CONTRACT CHANGE ORDER NO. __
SHEET ____ OF ____

MARK	DATE	DESCRIPTIONS	BY	CH'D	CCO
REVISIONS					
3	11/04/11	TOWER ELEVATOR EXTENSION	JNB	FS	203S2
2	08/26/11	ELEVATOR DETAILS	JNB	FS	85
1	07/17/09	ELEVATOR DETAILS	JNB	FS	85

SAN FRANCISCO OAKLAND BAY BRIDGE
EAST SPAN SEISMIC SAFETY PROJECT
SELF-ANCHORED SUSPENSION BRIDGE
(SUPERSTRUCTURE & TOWER)

TOWER ELEVATOR ENCLOSURE DETAILS NO. 1

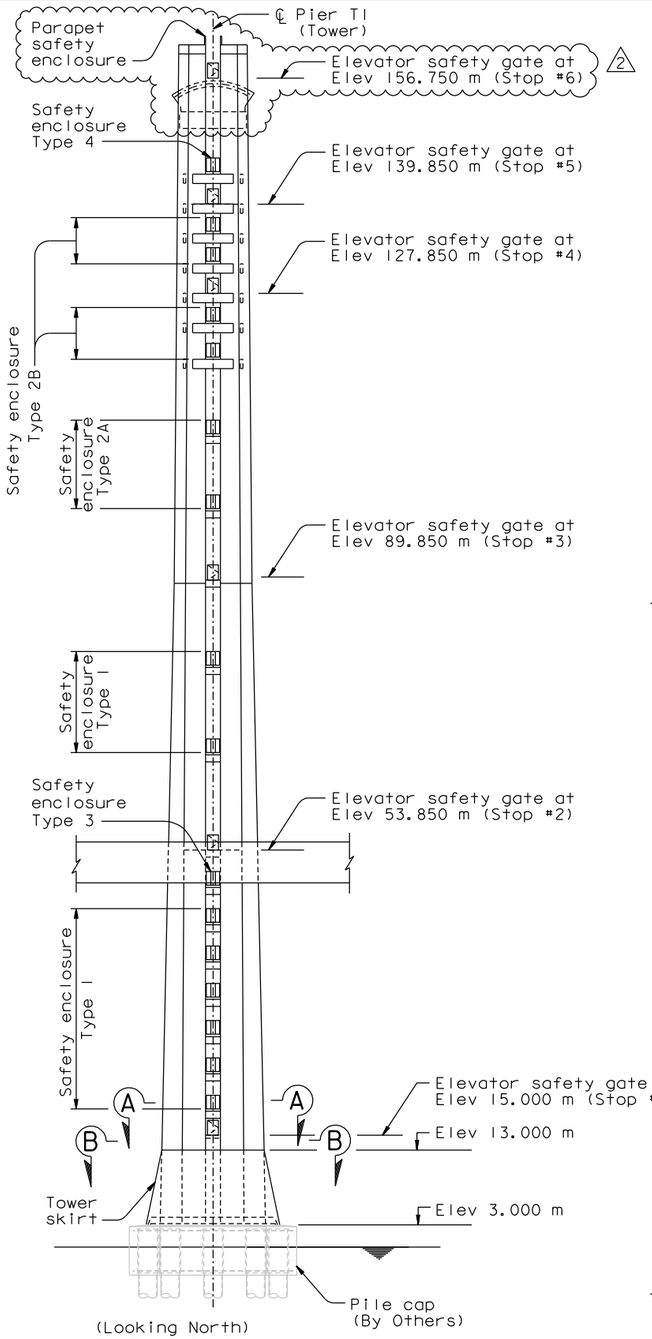
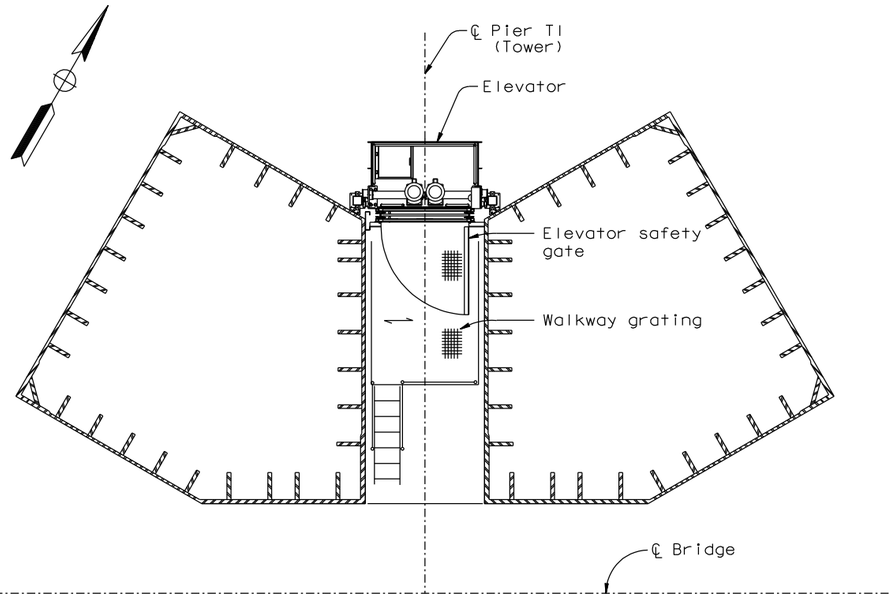
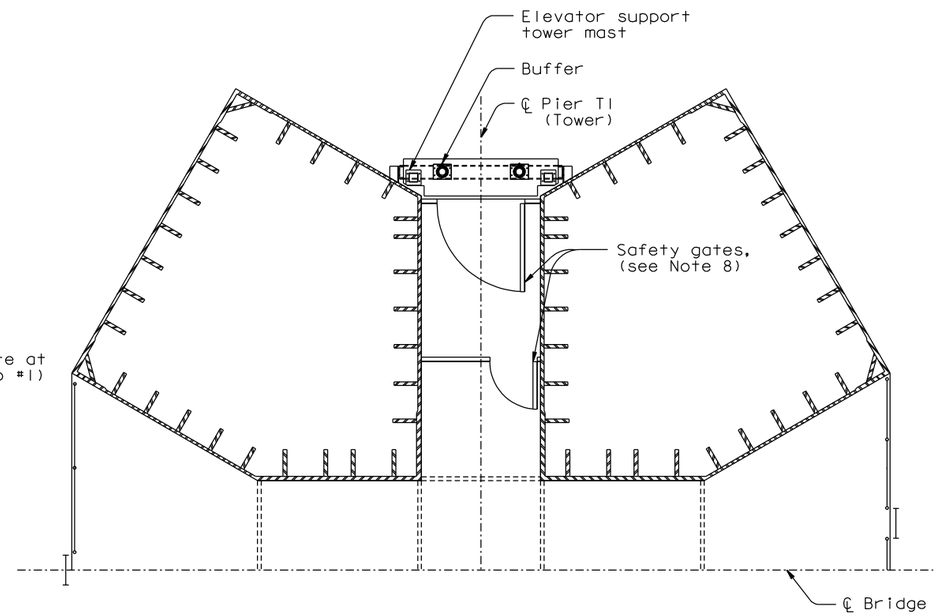
MARK	DATE	DESCRIPTIONS	BY	CH'D	CCO#
		REVISIONS			
2	11/04/11	TOWER ELEVATOR EXTENSION	AB	TH	203S2
1	11/02/11	ELEVATOR DETAILS	GM	TH	85
0	08/26/11	ELEVATOR DETAILS	GM	TH	85

10. For elevator safety gate details at Elevator Stop #6, see "Tower Elevator Enclosure Details No.5" sheet. 2
11. For parapet safety enclosure details, see "Tower Elevator Enclosure Details No.6" sheet.

TOWER ELEVATOR ENCLOSURE DETAILS NO.6

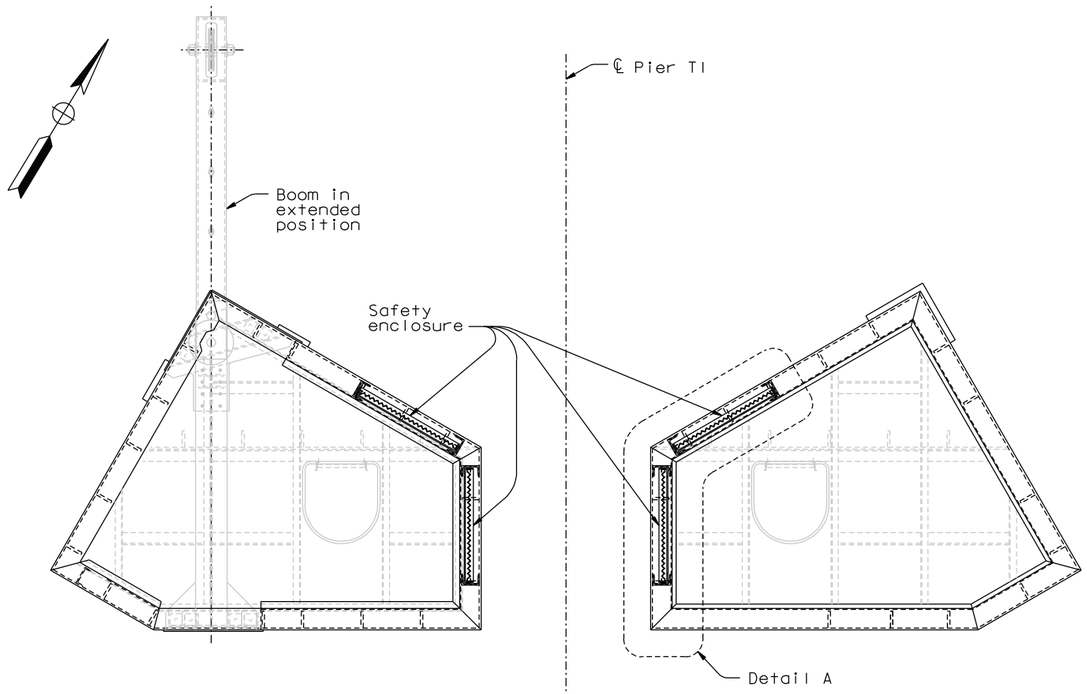
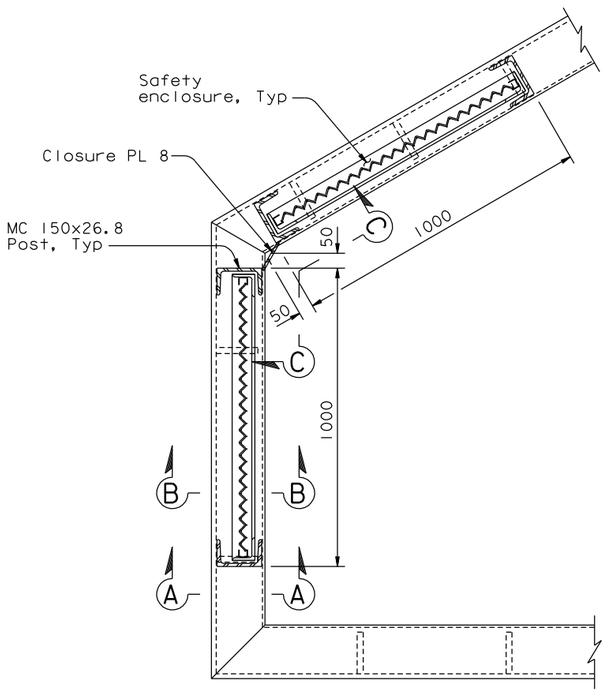
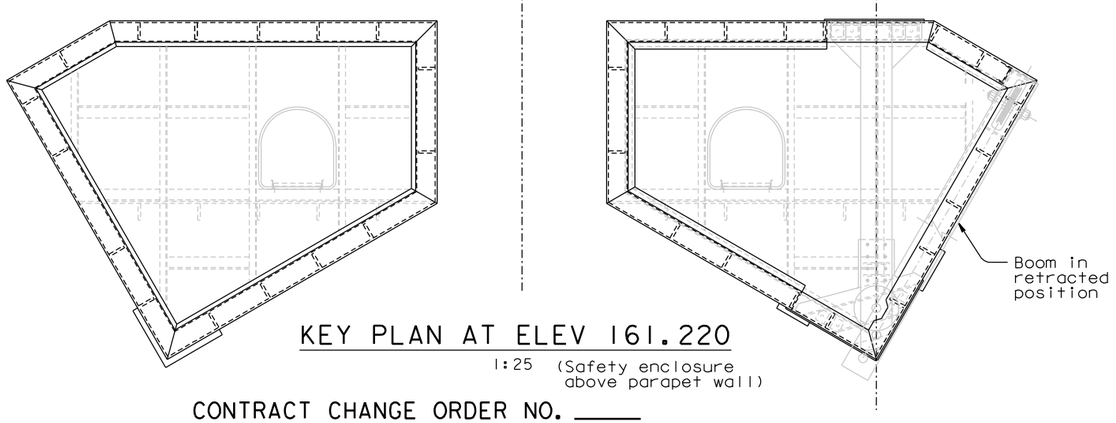
MARK	DATE	REVISIONS	BY	CH'D	CCO#
0	11/04/11	TOWER ELEVATOR SAFETY ENCLOSURE	NV	MN	203S2

TOWER ELEVATOR ENCLOSURE DETAILS NO. 7

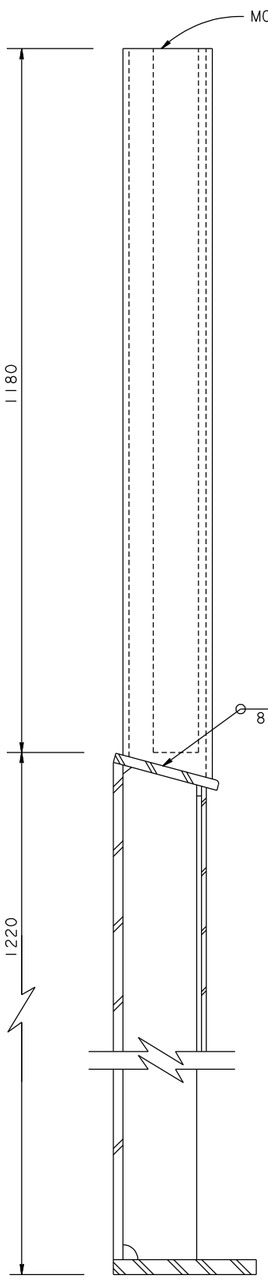
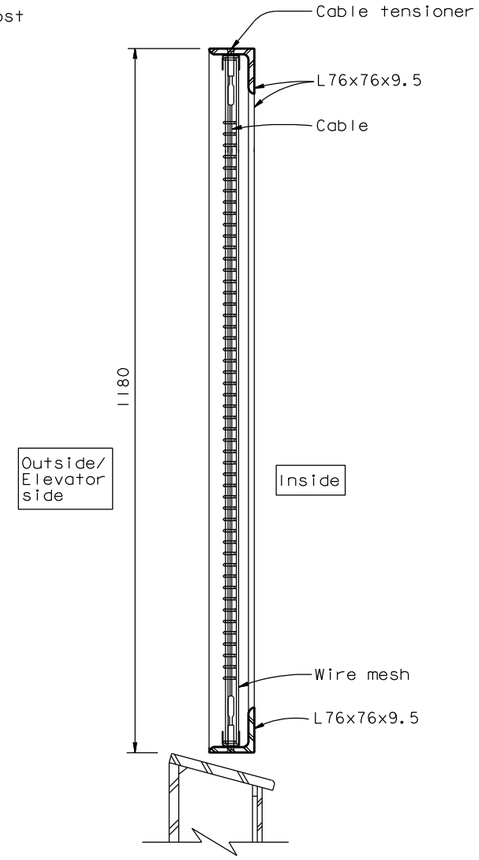
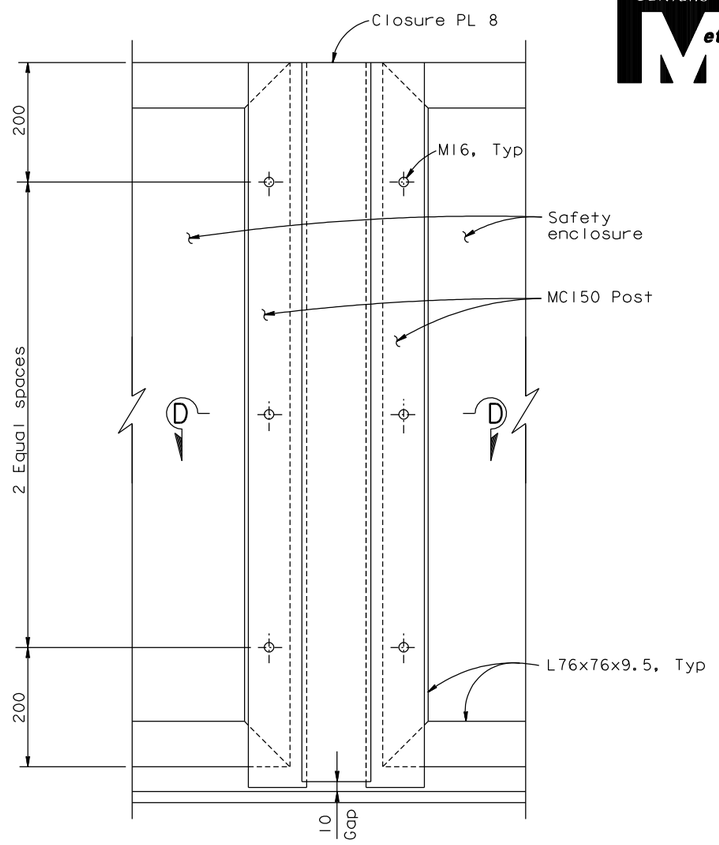
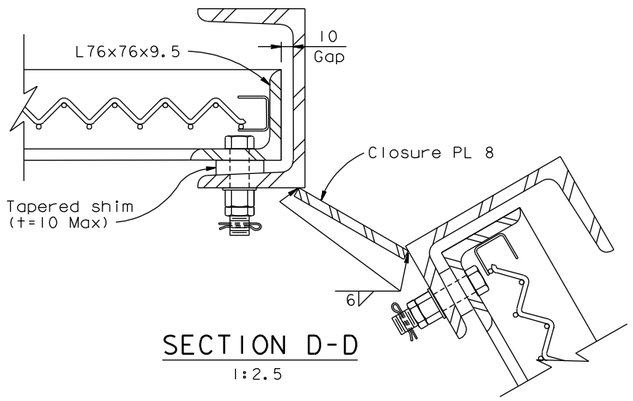
MARK	DATE	REVISIONS	BY	CH'D	CCO#
0	11/04/11	TOWER ELEVATOR EXTENSION	NV	MN	203S2

TOWER ELEVATOR EXTENSION DETAILS NO. 2

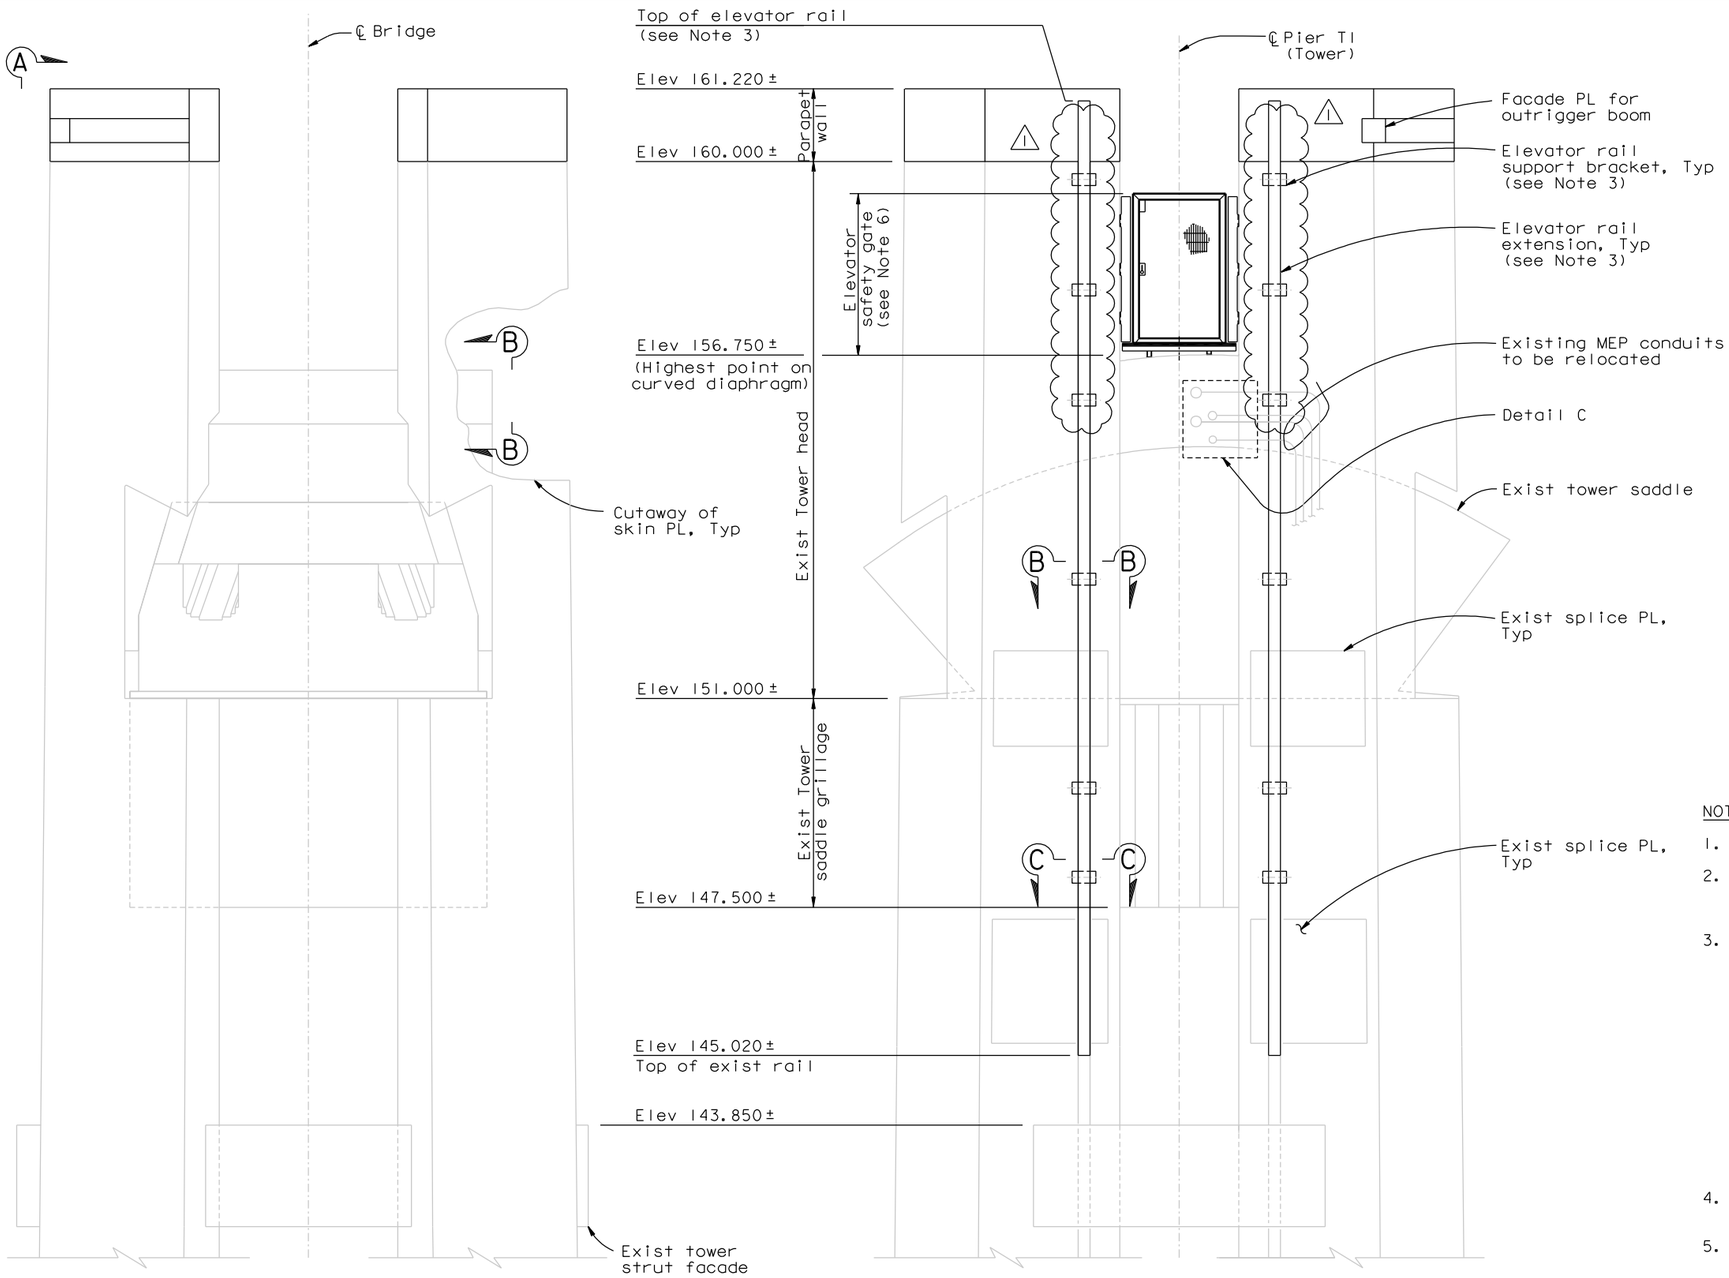
MARK	DATE	DESCRIPTIONS	BY	CH'D	CCO#
1	11/04/11	TOWER ELEVATOR EXTENSION	NV	MN	203S2
0	09/16/11	TOWER SUSPENDER CABLE & ELEVATOR	NV	MN	203S1

3. The following shall be determined by the elevator manufacturer and submitted for review and approval of the Engineer:
   - Details and locations of elevator rail support brackets and connection to supporting structure. Spacing of support brackets shall not exceed 3048 mm.

- Top of elevator rail elevation and stopper details. Top of elevator rail shall not extend above top of parapet wall. (1)
   - Details of elevator rail (mast and rack) and connections to support brackets.
